To: Director – Infrastructure Projects Department of Planning and Environment Application number – SSI 13_6136 Major Project Assessment GPO Box 39 Sydney NSW 2001.	From: David Law. A Resident in West Pennant Hills. Email Address: davlawnw@t@gmail.com
Ref: S20140901a Total 2 pages	Date: 1 st Sept 2014
Subject : 1. Tunnel Truck path in NorthConnex Southern Interchange 2. Air Quality Ventilation Outlet at Southern Interchange Attached tw0 submissions – Ref S20140828a and S20140805a

Att: Director –Infrastructure Projects
Department of Planning and Environment
Application number –SSI 13_6136
Major Projects Assessment
GPO Box 39 Sydney NSW 2001.

Att: **Director –Infrastructure Projects**
Department of Planning and Environment
Application number –**SSI 13_6136**
Major Projects Assessment
GPO Box 39 Sydney NSW 2001.

Figure.1 Impact of air quality affected by wind air flow within 1 KM resident area.

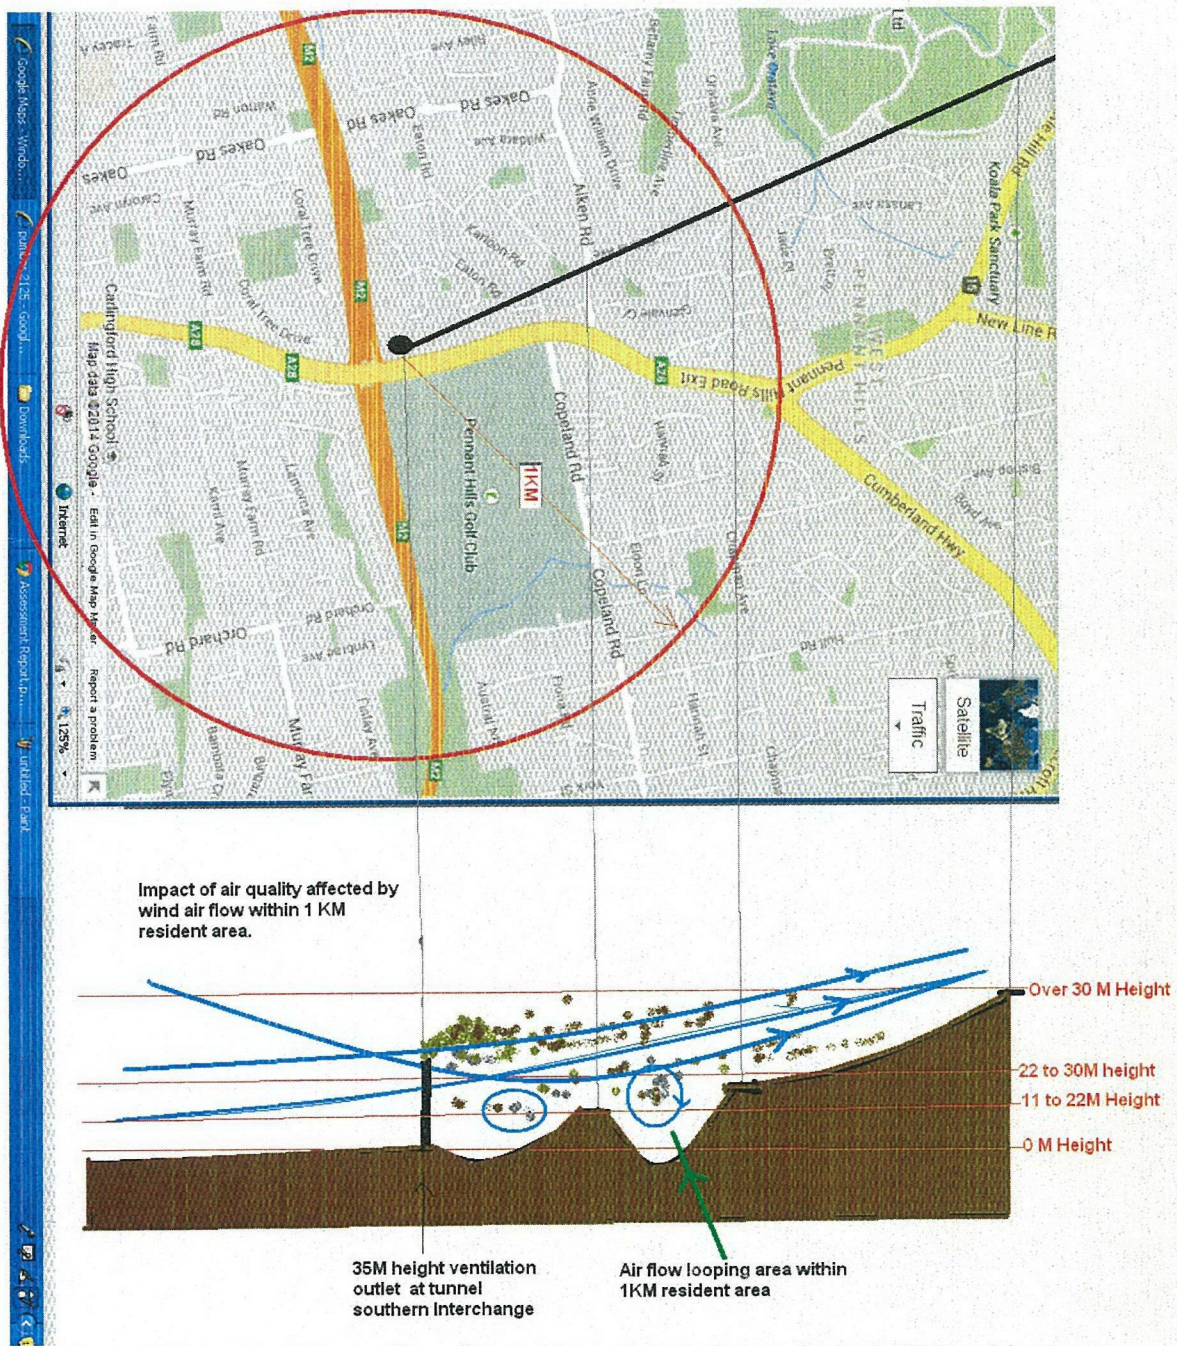
The Hill terrain at the NorthConnex southern interchange is complicate. Within 1 KM surrounding area (see Figure1), relative to the (0m) height at southern ventilation outlet, it has 22m height at 1 Aiken road, more than 30m height at Thompsons corner and -20m height in Dehlson ave (West pennant hill Val).

Can the high concentrated pollutant be distributed out into the air within this 1KM area and maintaining good (2014) Air Quality standard? The answer is not clear yet till the real operation (but it is too late). As such, two detail models proposed in the attached request for further detail simulation the impact of real environment within 1KM surrounding area at southern interchange. Also, please, reserve the sufficient space to build the air treatment at the (southern interchange) ventilation outlets planning for the possible solution to improve the air quality if it failed to maintain the (2014) Air Quality Standard within 2KM surrounding area.

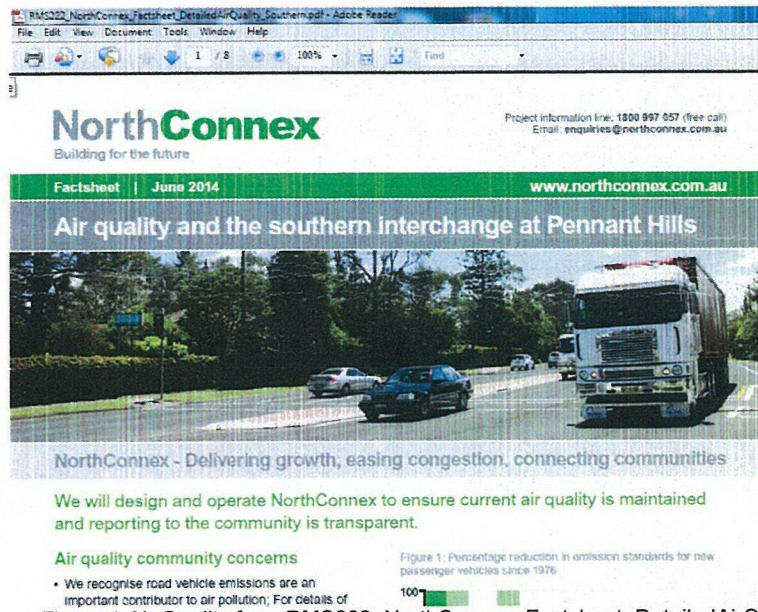
Figure 1 is the Fact sheet (June 2014) Air Quality proposed solution by NorthConnex for Southern Interchange. Dual (one upward and one downward/reversed) Air flow tunnels (9.2 KM) will be built from southern interchanges (144M Aust Height Datum) to northern interchange (180M Aus Height Datum). An estimated 4,000vehicles/hr will pass through the tunnel. High concentrated pollutant (bad air quality) generated by In-tunnel vehicles and will be drawn away by moving traffic and then extraction through a (30~35) M height ventilation outlet at both entries. Filtration technology (M5 East Tunnel filtration plant) will NOT be used.

This submission split into five parts in order to identify how the high air quality (2014) standard can be maintain/monitor/control within 2 KM surrounding resident area when the high concentrated pollutant emitted from both (35M height) ventilation outlets for NorthConnex tunnel operation in 2019:

Figure 1. NorthConnex Southern Interchange

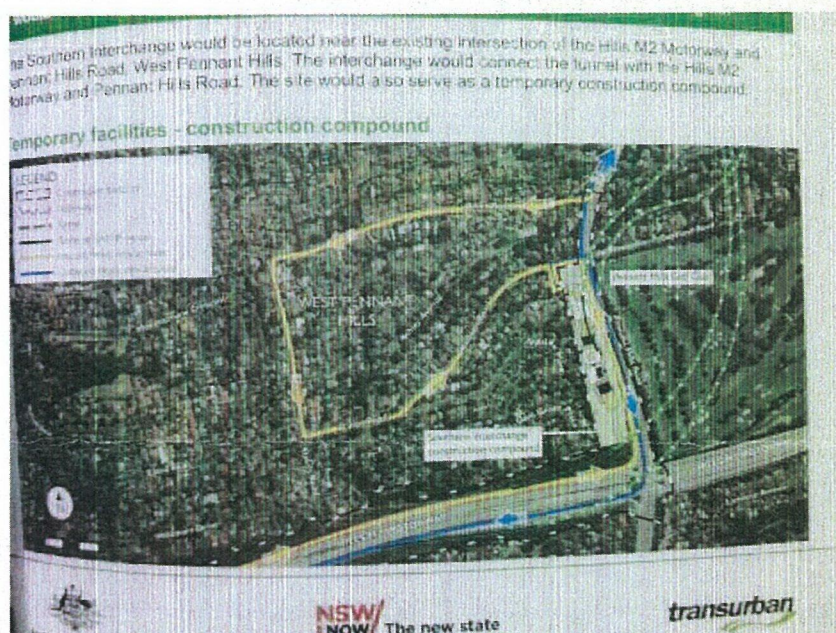
A. Comments to (Figure 1) NorthConnex Proposal below:

A1. The Impacts/Risks to the hill's resident area are:

1. **Impact of further overloading the road Traffic** – existing traffic is being overloading in the said suburban streets during the peak/busy hours. How could the said suburban streets further overloading the additional (1480/day) heavy tunnel trucks and (330/day) small cars.
2. **Impact of (high dB) truck Noise/Min** – High dB noise (each min) produced by each tunnel heavy truck pass through said suburban streets. And high impulses of truck's break stop noise.
3. **Impact of Air pollution created by the truck/min to the resident.**
4. **Impact of Soil dust** affects all resident for each heavy tunnel truck passing the said suburban streets.
5. NorthConnex requires paying construction cost to enlarge the turning space for the tunnel trucks driving a (90 deg) angle turning from Oakes road into Eaton road.

6. **Maintenance cost.** Road (suburban streets) damaged required high Maintenance cost (to be paid by NorthConnex)
7. **Impact of vehicles type change,** Council classified the type of heavy truck (more than 3 tones) is restricted to pass through the said suburban streets. The purpose is reduced noise to the resident.
8. **Waste of truck oil consumption.** Each day (1480) heavy Trucks drive on the proposed suburban streets. How much cost will be waste in the truck Oil consumption if it can be avoid.
9. **Waste of truck operation cost.** Each day, (1480) heavy trucks run through the suburban streets. How much cost/time will be spend on the Truck driver to delivery soil on the road. The operation cost can be reduced if it can be avoid.
- 10 more will be coming...etc.

Figure 2. Road Inspection at Junction of Copeland/Eaton/Pennant Hill Roads

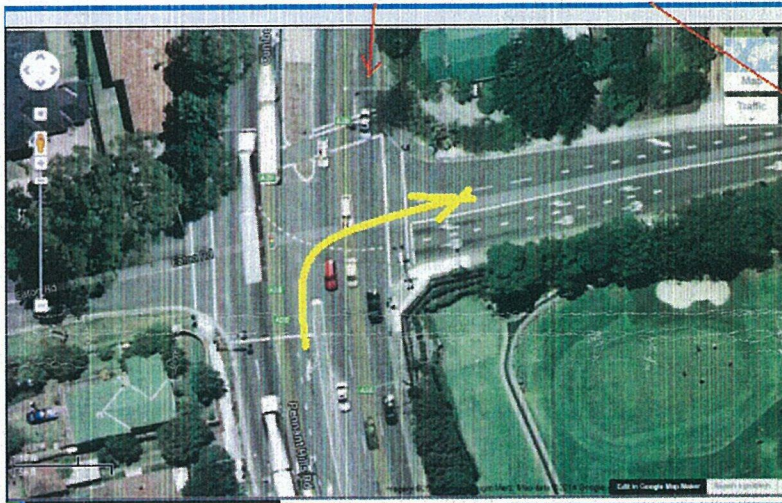
B. Existing traffic condition inspects at Eaton Road Junction – Figure 2 is the road inspection at 5:00pm (busy hour in week day)

- B1. Vehicles North Bound (Parramatta -> Hornsby) – 1min 10sec
- B2. Vehicles South Bound (Hornsby->Parramatta) – 1 min
- B3. Vehicles allow left turn from pennant hill road in to Copeland road (15sec).
- B4. Vehicles from Eaton road to Copeland road or left/right turn to pennant hill road (10 ~15sec).
- B5. Vehicles from Eaton road to Copeland road to Eaton road or left turn to pennant hill road. (10 ~15sec).

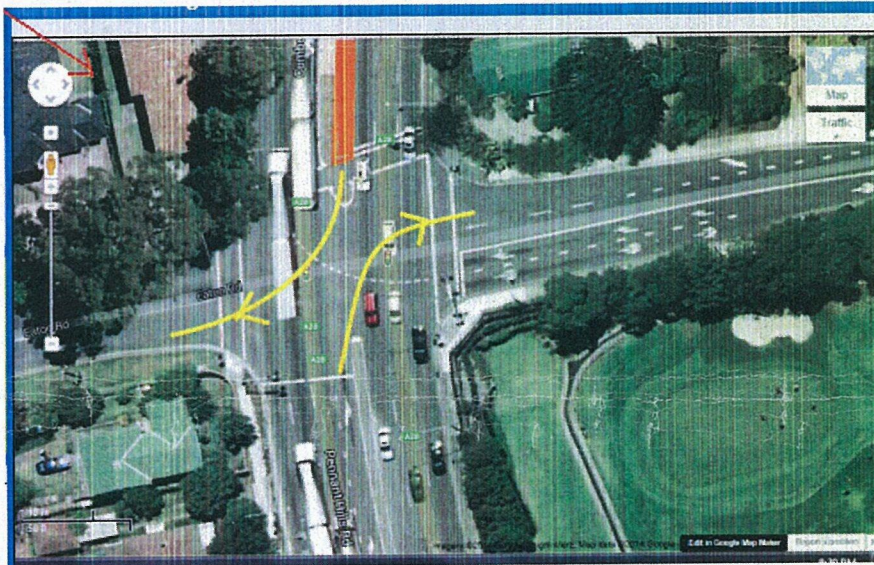
C1. Build an additional (Tunnel) Truck Link. Closed to the junction of Eaton road and Pennant hill road, there is a large (Safety Island) area along the middle of pennant hills road (between Aiken and Eaton road. It has enough space to building an additional heavy truck link that delicates only used by the heavy (tunnel) truck to turn left from pennant hill road to Eaton road.

C2. Time schedule for the truck turning to Eaton Site. Refer to the traffic timing schedule (B3), when the vehicles take (15 sec) to left turn from pennant hill road into Copeland road. It should allow the heavy tunnel truck to turn left turn from pennant hill road into Eaton road at the same time.

C3. Cost to build the Link. See A1 (5) NorthConnex requires construction cost to improve the road for the truck turning (90 dgs) angle from Oakes road to Eaton road. Why not spend the cost to build an additional truck link specified in C1?
